Name: Mesa National Bank – Site Plan Review/Minor Change- Drive Thru-SW Corner 12th/F Rd

GENERAL PROJECT REPORT (PROJECT SUMMARY)
MESA NATIONAL BANK - PATTERSON BRANCH
1199 Patterson Road
Grand Junction, Colorado 81501

REVIEW COMMENTS

TITLE HEADING: Site Plan Review & Minor Change -
Drive-thru for Bank - Village Faire
Shopping Center

1 PROPOSED DRIVE-UP KENDEL SITE PLAN

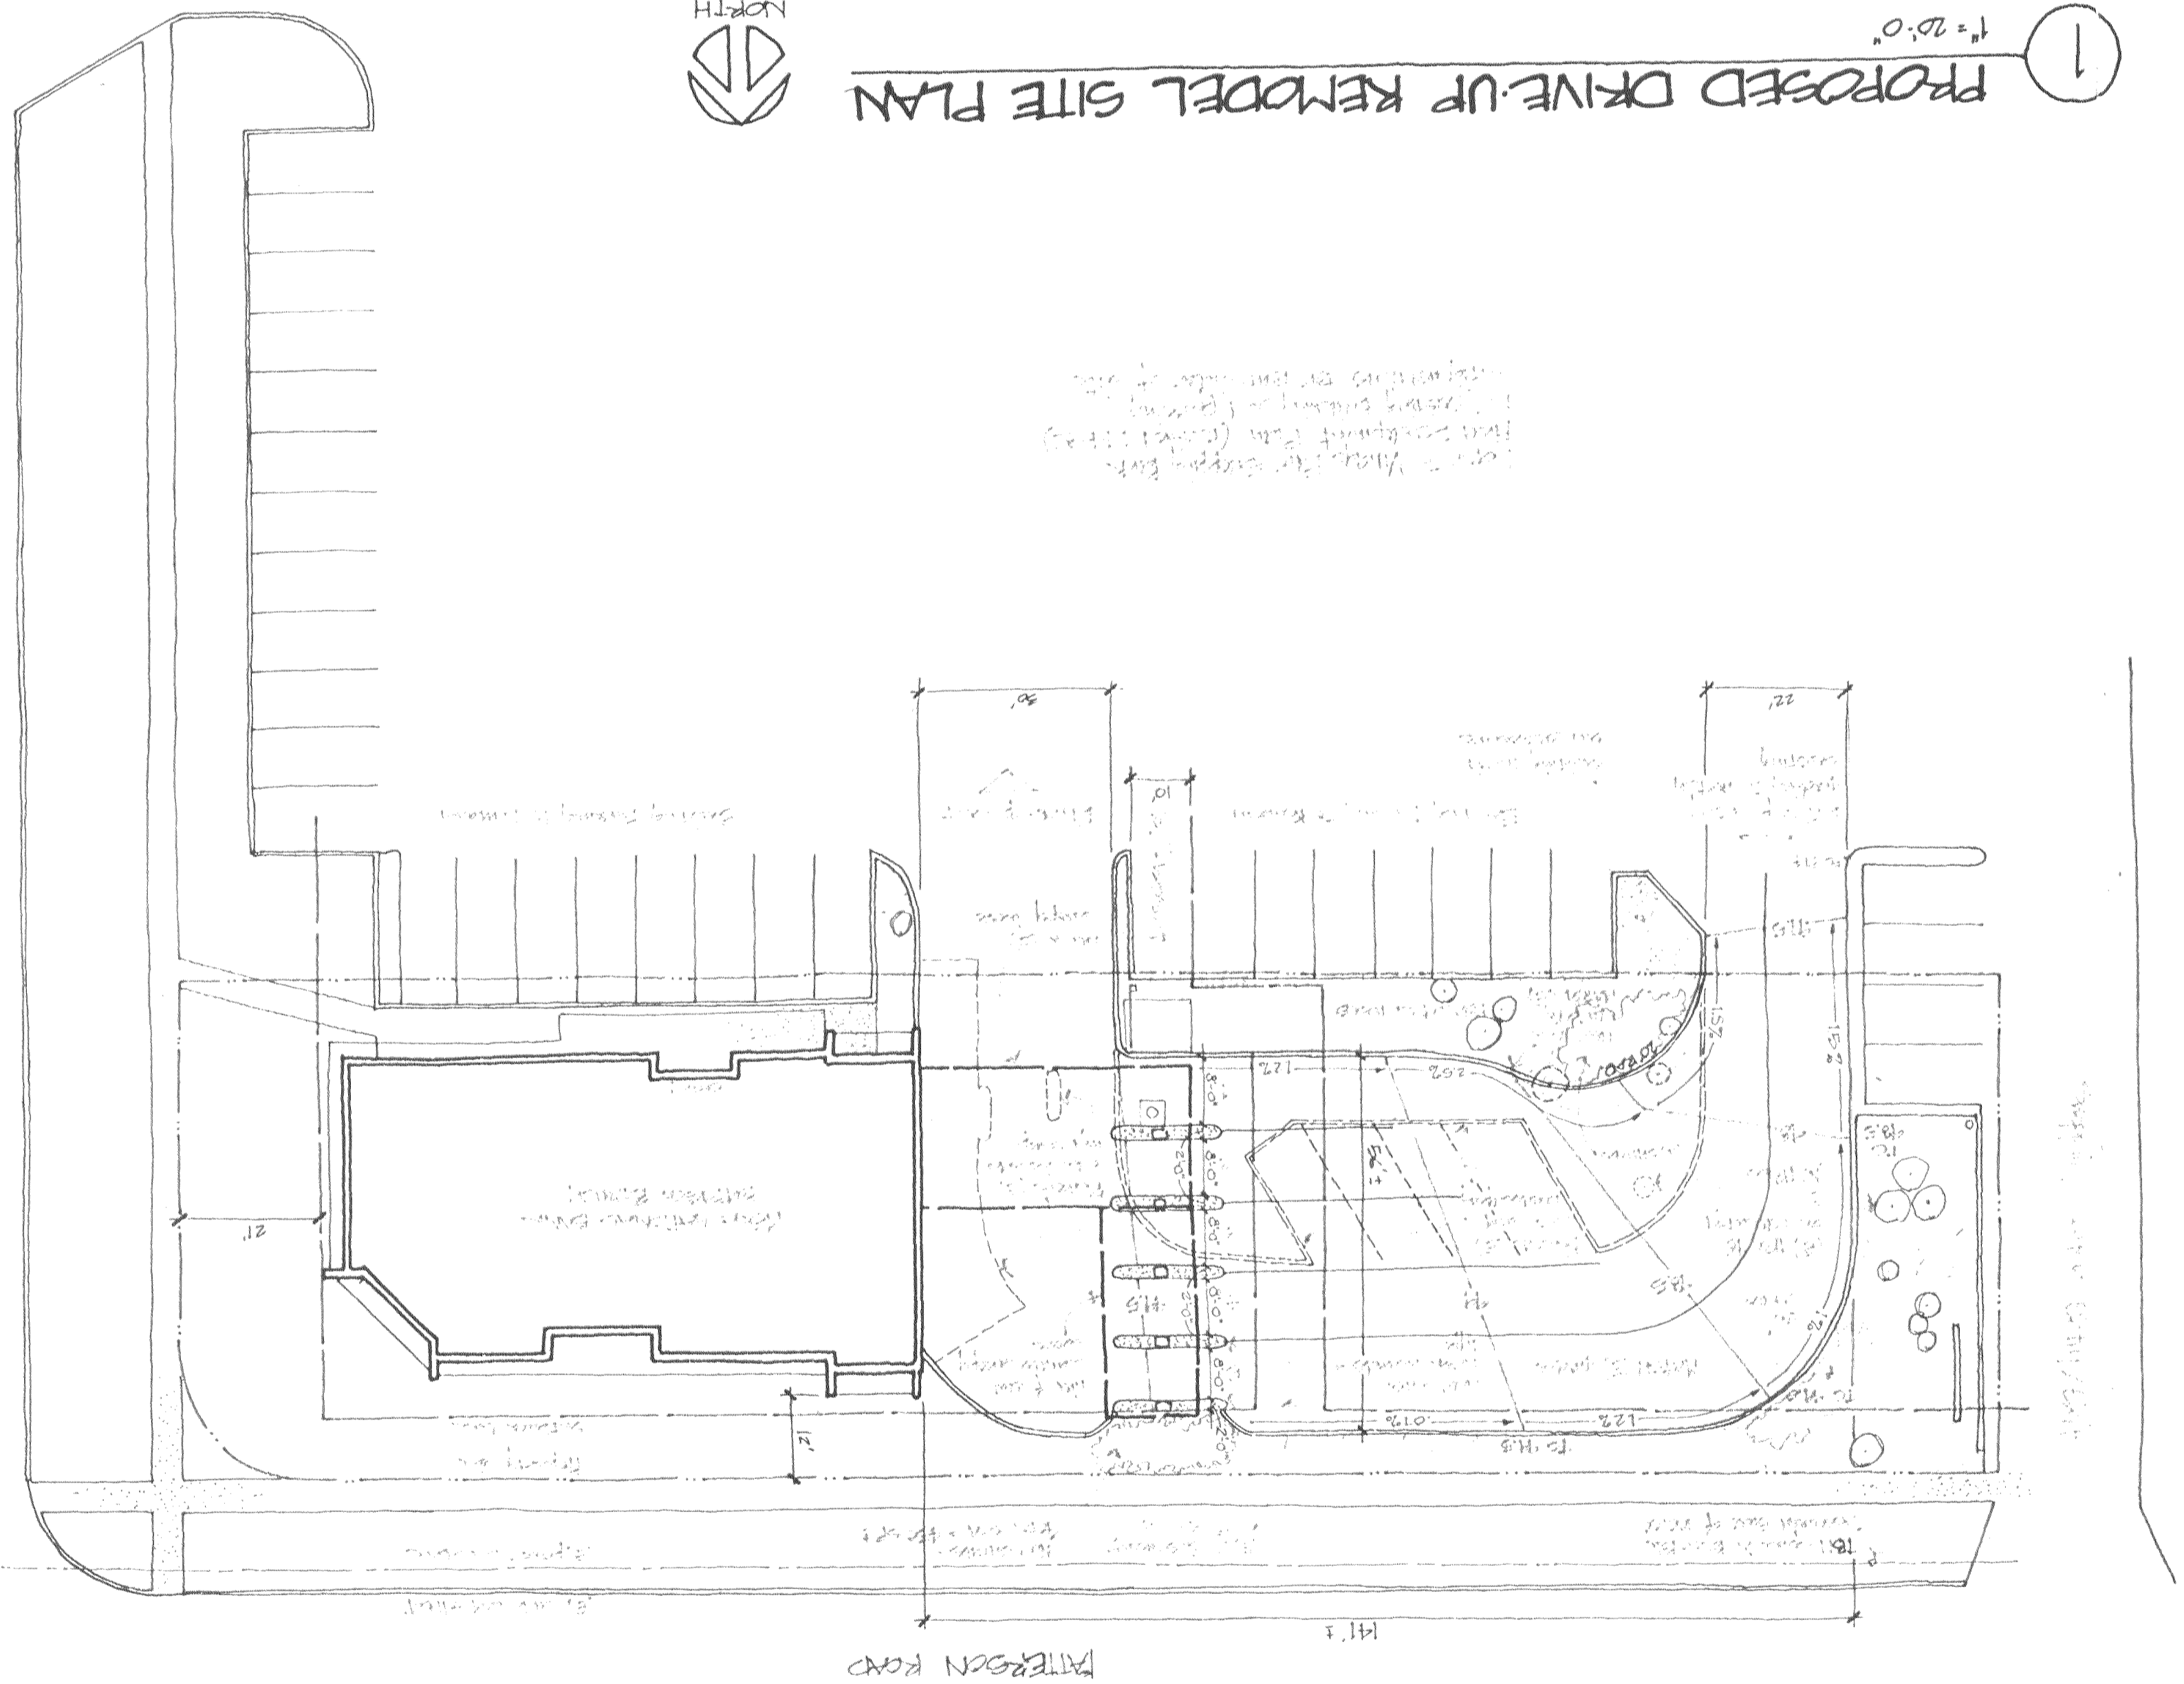
1. Show detail for new canopy and attachment. What is the clearance height of the canopy?
2. Show the lane widths.
3. Show the dimensions of the new concrete islands
4. Show detail and elevations on new concrete curbs.
5. Show all radii on curves. Is there sufficient room for vehicles to turn and maneuver, especially into lane 1?
6. Show proposed pavement elevations.
7. What is the 10' easement for?
8. Drainage fee as calculated is insignificant - no fee required.

1. Is the canopy going to cover all 5 drive-up windows? If so, what type of lighting will be installed over the vehicles?
2. Would suggest the curve of the driveway access to lane one be change to what is shown in red on the attached plan. I feel if you have cars backed up in lane 2, the vehicles won't be able to get into lane 1. Also, it will allow vehicles to immediately enter lane 1 without having to maneuver their vehicle around the curve and any cars backed up in lane 2.

1. Approximately 1,120 s.f. of landscaping is to be removed; of which according to Code, 40% is to be covered in shrubs and 3 trees provided. Thus, additional shrubs which cover approximately 450 s.f. and 3 trees are required somewhere on the site to replace the landscaping which is to be removed. Minimum plant size is 1-1/2" caliper for deciduous trees, 6 feet for coniferous trees, and five gallons for shrubs. Location of these plantings are subject to review by City staff. Please provide revised plan indicating new plantings.
2. If planting will not be done until after expected completion date of the drive-thru, an Improvements Agreement and Guarantee is required (see enclosed form).
3. A letter of approval from the property owner is required prior to issuance of a Planning Clearance for a Building Permit.

1. The new canopy color, material, and framework is to match the existing canopies already attached to the bank building. The clearance height of the new canopy is to match the height of the existing drive-up canopy and building soffit, which is approximately 9'-10 1/2" above finish floor. Since the top of the islands are about 6" above the asphalt, then clearance is closer to 10'-4".

2. The lane widths are a standard 8'-0" in width, and are shown on the drawing.
3. The standard concrete islands supporting the kiosk equipment are 2'-0" in width by 16'-0" in length.

4. Drawing A-1 shows the elevations of the top of curbs, noted as "TC" directly above the contour lines. Notation indicates that the new curbs are to match the existing curbs.

5. The inside radius for the turn to lane 1 will be changed to 20'-0" +/-, and the minimum inside turning radius for a vehicle is 19'-0" +/-.
6. The new pavement elevations are an extension of the existing pavement elevations, and are indicated as contour lines on drawing A-1.

7. The existing 10' easement is identified as a utility easement in a survey conducted by Monument Surveying Company dated 18 Aug 1993. This easement runs parallel to the north property line, and north-south across the existing drive-up as shown and identified on drawing A-1.

1. The existing gas meter currently located on the north face, is to be moved to the south face of the existing canopy support structure. The electrical transformer, and the telephone box are to remain undisturbed.

1. The existing islands are to be removed, and the new islands will be covered by the existing and new canopies. The two southern-most kiosk islands will be covered by the existing canopy, and the new canopy is to cover the remaining three islands to the north.
A new light will be placed over each vehicle drive-up lane to allow sufficient illumination to conduct business with bank customers at dusk and dark, and provide security.
2. The reason for the radius of the curb, is to allow as much of the original landscaping to remain as possible with the new expansion of the drive-up, and will have a radius of 20'-0" +/-.

1. The 450 square feet of shrubs, and 3 new trees will be provided by the bank. The anticipated location of the new vegetation is shown on the revised drawing.
2. The Improvements Agreement and Guarantee has been forwarded to the bank for review, they will implement the guarantee if the construction is to occur prior to the landscaping.
3. A letter of approval from the property owner/property manager of (Leisure-White Development Company) will be forwarded by the bank.
